High Performance Visible Laser Diode Scanner

(Catalog Numbers 2755-LD4z1, -LD4z4, LD8z1, -LD8z4)

This document describes an update to the High Performance Visible Laser Diode Scanner User Manual. Keep this Document Update with the manual.

Description of Change

Figure 5.2

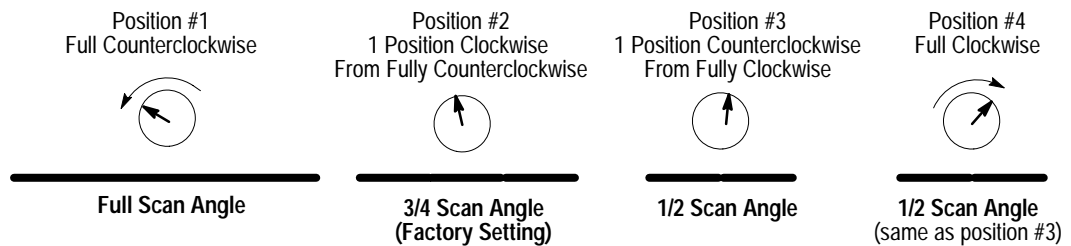
- Page 3-13, under “Example 1:”, change:
A = 200 scans/second–5% = 190 scans/second (minimum scan rate), to:
A = **186** scans/second–**5.4%** = **176** scans/second (minimum scan rate)
- Page 3-13, under “Example 1:”, change:
S = 190 scans/second x 1 inch/(25 inches/second)
S = 7.6 scans, to:
S = **176** scans/second x 1 inch / (25 inches/second)
S = **7.04** scans
- Chapter 7 Specifications under Optical “Scan Rate (Nominal)”, change:
Catalog No. 2755-LD4 200 Scans/Second, to:
Catalog No. 2755-LD4 **186** Scans/Second
- Page 5-3, factory default setting for the scan angle is $3/4$.
